A303 - Stonehenge to Berwick Down Scheme

Written Representation of:
Winterbourne Stoke Parish Council
Registration ID 20019107
&
Dr A D Shuttleworth
Registration ID 20018263

Figure 1: Map of Winterbourne Stoke with associated keypoints (blue) and Wiltshire Council byway numbers (red)

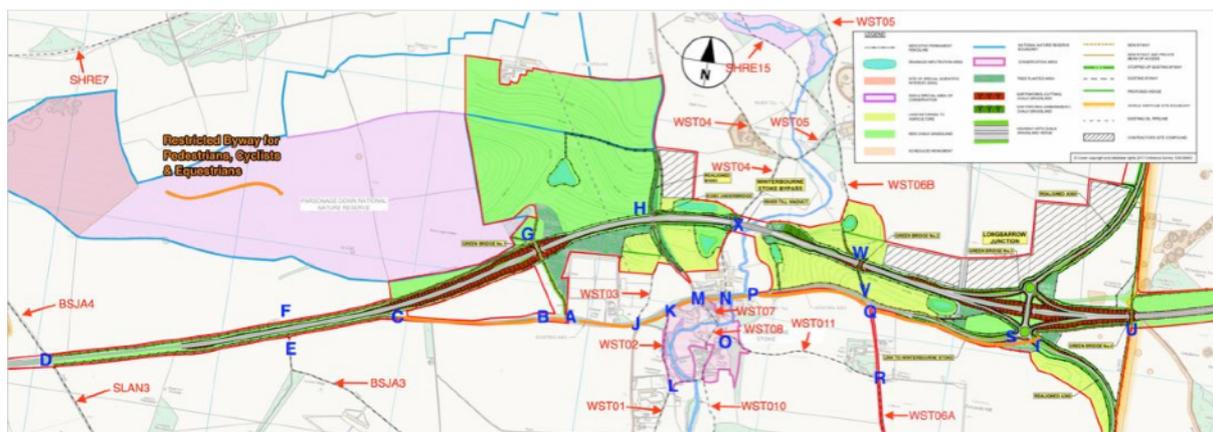
1.10 Given all the above, the western end of the scheme should be moved to the west of the Yarnbury Crossing at point D in Figure 1. To minimise these legitimate safety concerns, an underpass of the A303 should be provided (a bridge would not be appropriate at this point due to the archaeology). Entry/exits onto the A303 from SLAN3 and BSJA4 should be removed for the same reason and the gap in the central reservation could be stopped-up, enhancing traffic safety on the A303.

1.11 A safe crossing at point D is critical in joining byway networks to the north that run towards Wales and to Grovelly Wood and the Kings Way to the south - which connect byway networks westward to Dorset and Devon.

Figure 4: Map of Winterbourne Stoke with associated key points (blue) and Wiltshire Council byway numbers (red)

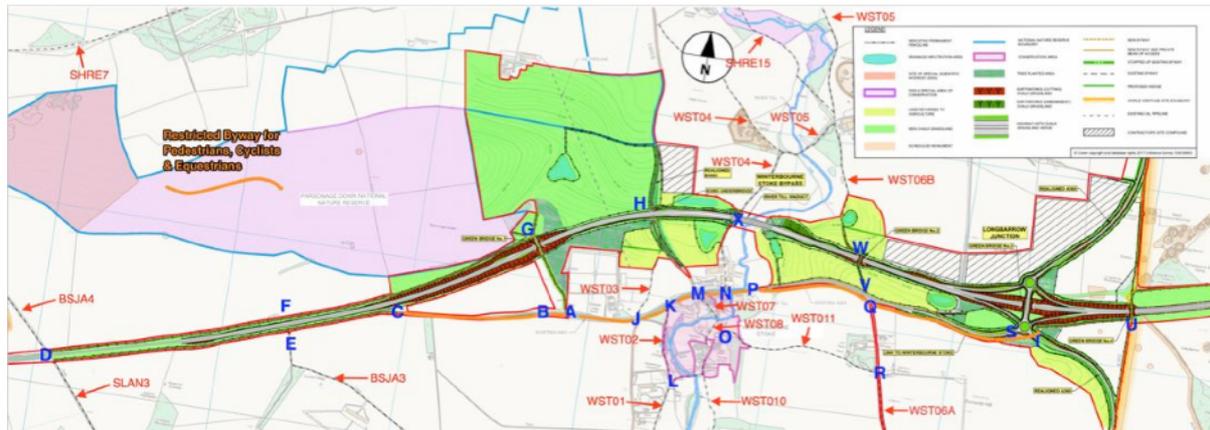
2.16. HE's tertiary claim for Green Bridge 1, that it is: "*maintaining and enhancing the public rights of way, and providing agricultural access*" is, at least superficially, more reasonable, but still bears closer examination as it betrays a near total lack of understanding of local issues. There are currently no usable ROW close to the site of the proposed Green Bridge, so the claim of maintaining ROW is rather

overstated. WST03 is currently overgrown, gated and blocked by barbed wire at its southern end.

2.17 The needs of agricultural access could be better met by providing an access from the B3083, north of the A303. So, access to fields at G in Fig. 4 above, instead of being via Green Bridge 1 (A-G), should be from the northern side of the B3083, westwards from point H to point G.
